AMERICAN FORK CITY
DEVELOPMENT REVIEW COMMITTEE AGENDA

Review and action on an application for a Preliminary Plat, known as Holmes Gunther Preliminary Plan App #2 for the proposed Ellen's 2 Subdivision, located at 490 N Mary Pulley Dr. (900 E), American Fork City, UT 84003. The Preliminary Plat will be on approximately 5.16 acres and will be in the R1-9000 zoning designation.

ELLEN'S 2 SUBDIVISION
HOLMES HOMES
COVER SHEET

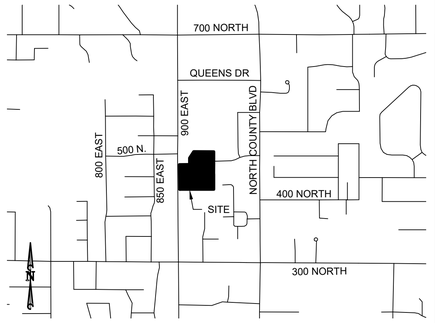
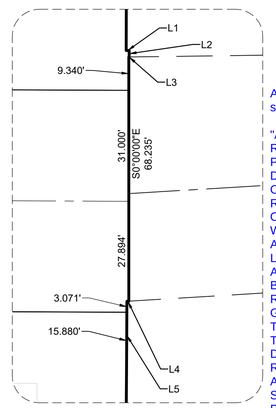
Address comment

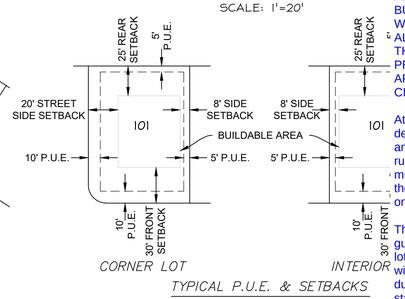
Add another note similar to this.

"ALL LOTS WILL BE REQUIRED TO PROVIDE A DEDICATED ON-LOT RETENTION BASIN OR SUMP SYSTEM WITH AN ACCOMPANYING LOT GRADING PLAN AS PART OF THE BUILDING PERMIT REVIEW PROCESS. GRADING PLAN IS TO DEMONSTRATE THAT ALL LOT DRAINAGE IS RETAINED ON LOT AND THAT NO STORM WATER IS PERMITTED TO DRAIN ONTO AN ADJACENT LOT. BUILDING PERMIT WILL NOT BE ALLOWED UNTIL THIS HAS BEEN PROVIDED AND APPROVED BY THE CITY"
